ERRATA

Illinois Route 47 (Reed Road to U.S. Route 14) McHenry County, Illinois

Job No. P-91-101-07

August 10, 2016

Figure 2-5 Existing (2011) and No Build (2040) Traffic Volumes

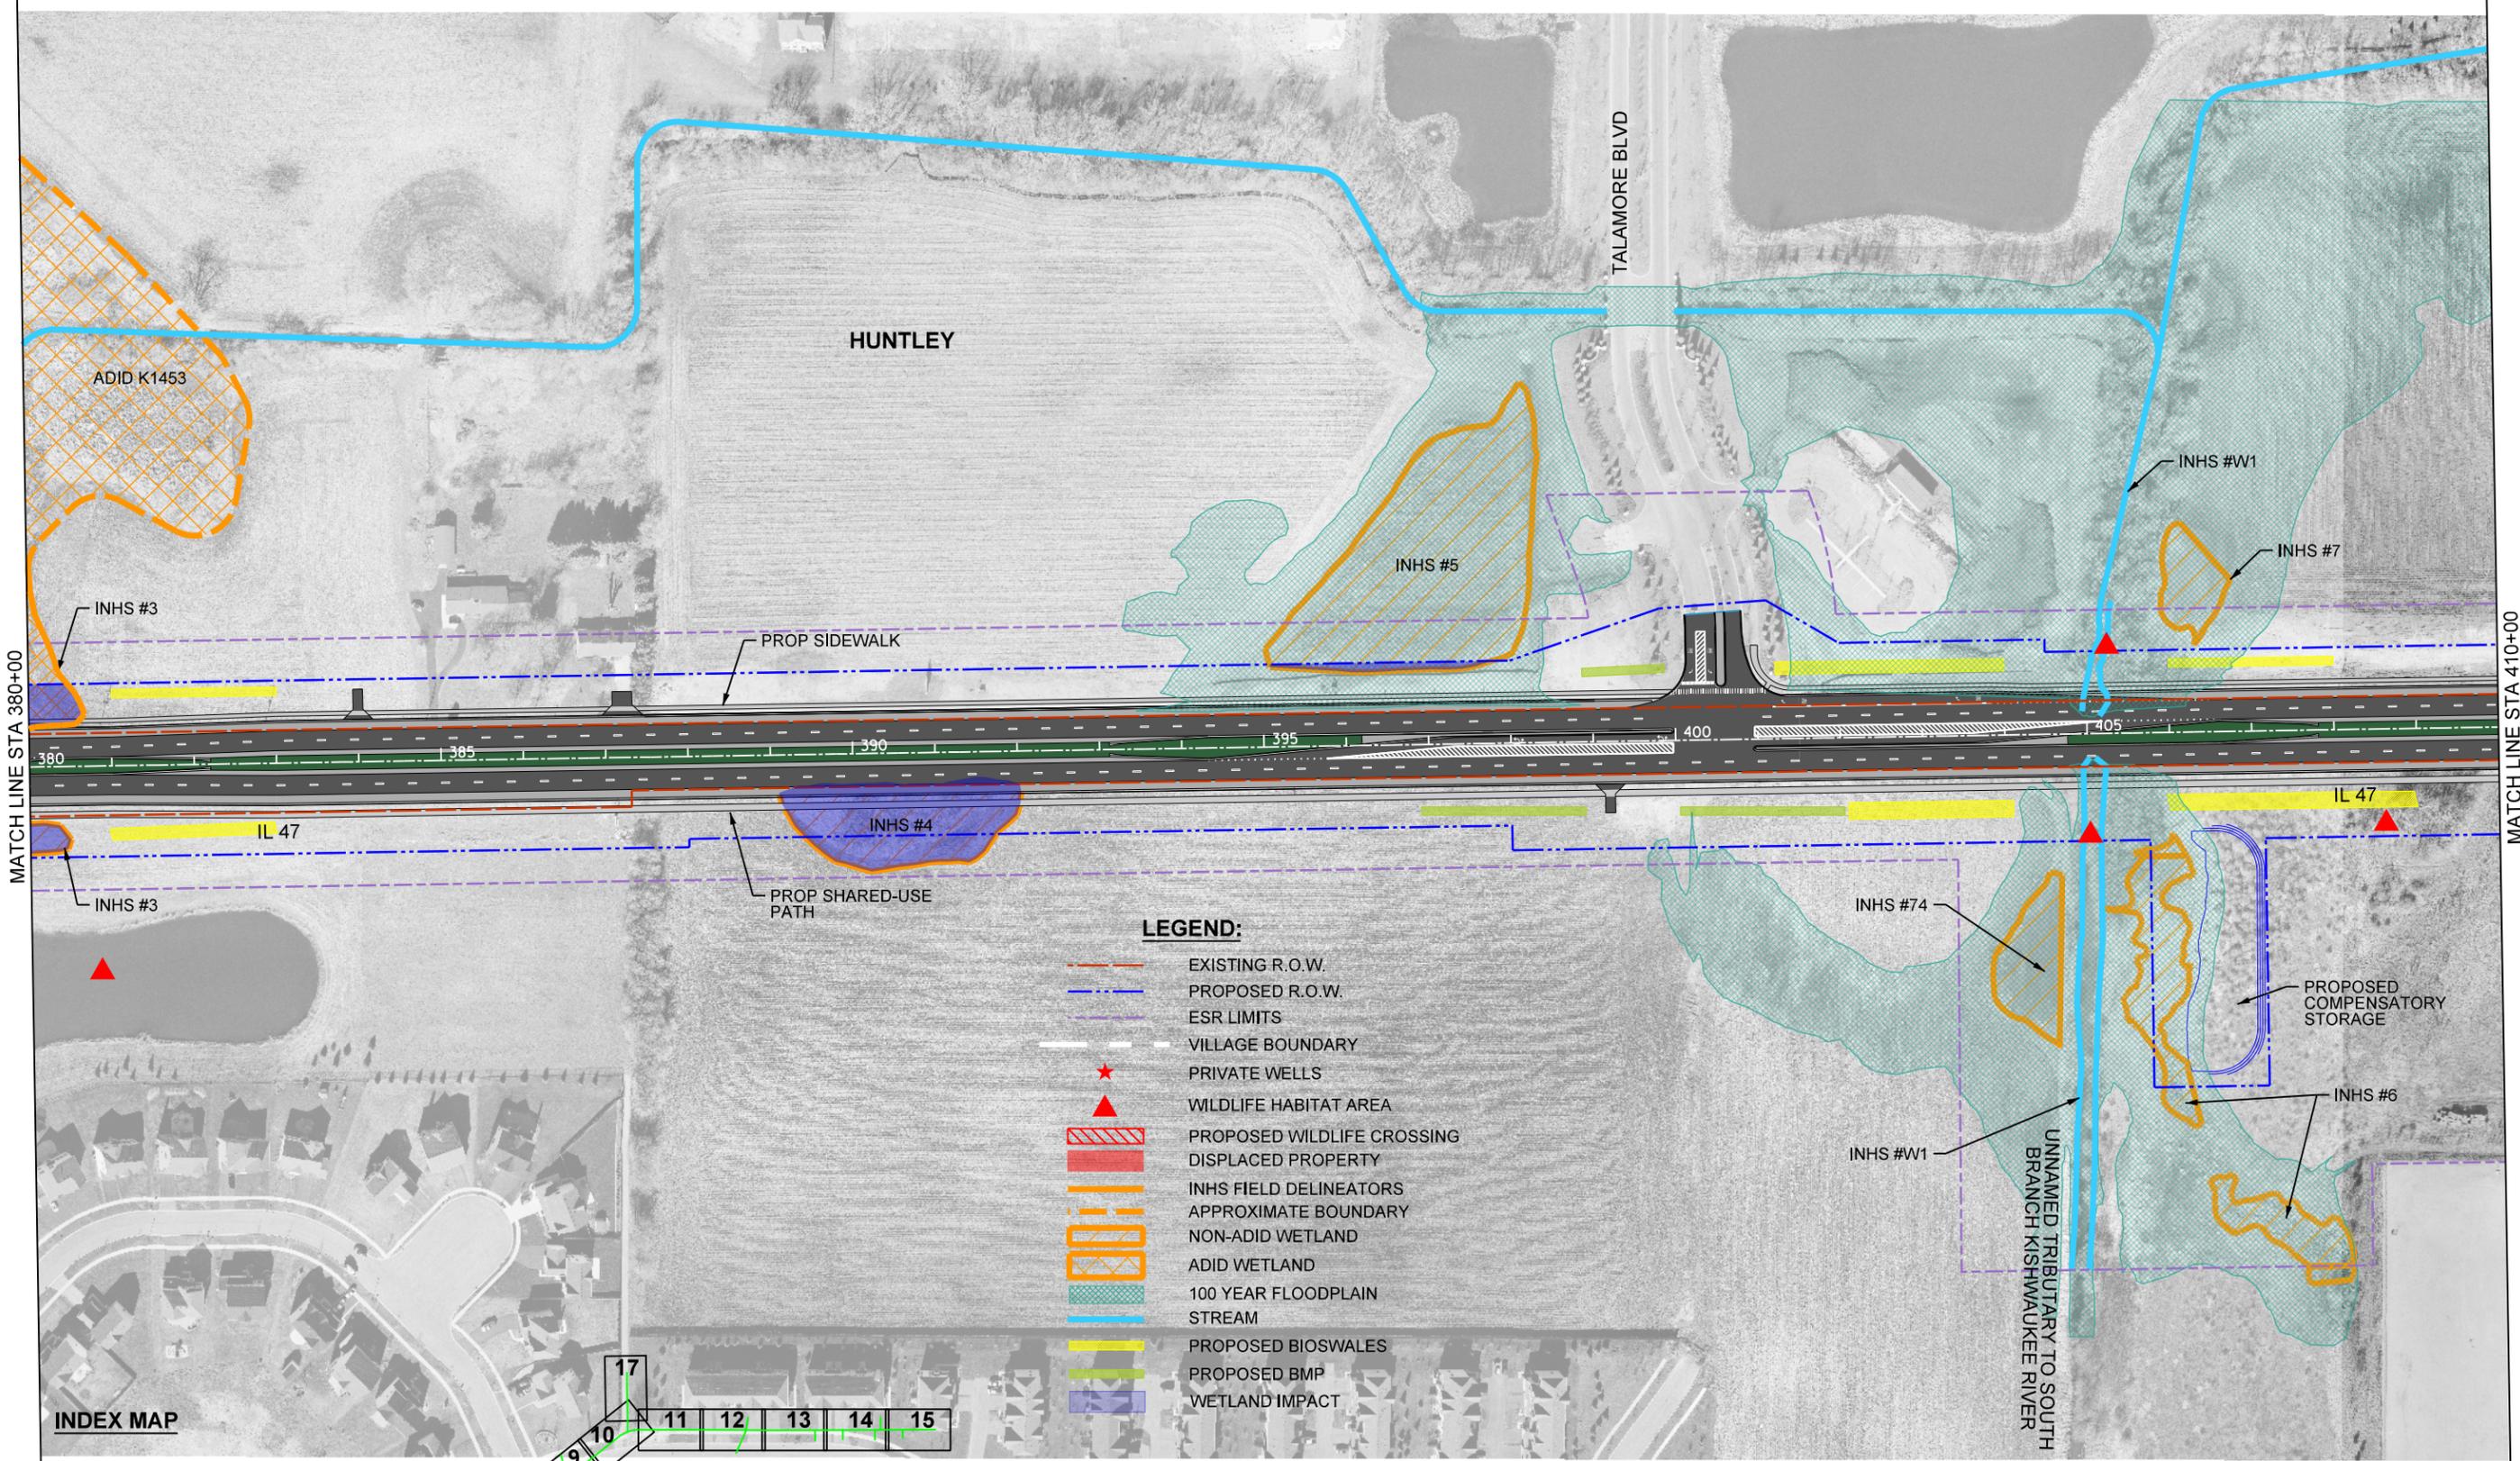
Replace Figure 2-5 with the attached revised Figure 2-5.

A sensitivity analysis was conducted with the new projected Build 2040 traffic data as shown in the revised Figure 2-5. There were still three CNEs for the Build improvement that were determined to approach, meet, or exceed the FHWA Noise Abatement Criteria, and warranted consideration of traffic noise abatement. Of those three, only one (CNE 16) remained viable since receptors for the other two CNEs will be acquired based on preliminary engineering and right-of-way requirements. CNE 16 was previously considered and evaluated for traffic noise abatement. Although it met the Feasibility criterion, it did not stand the test of reasonableness for the Noise Reduction Design Goal and Cost Effectiveness criterion. Therefore, the conclusion that highway traffic noise abatement measures are not likely to be implemented for the proposed IL 47 preliminary engineering design is still valid.
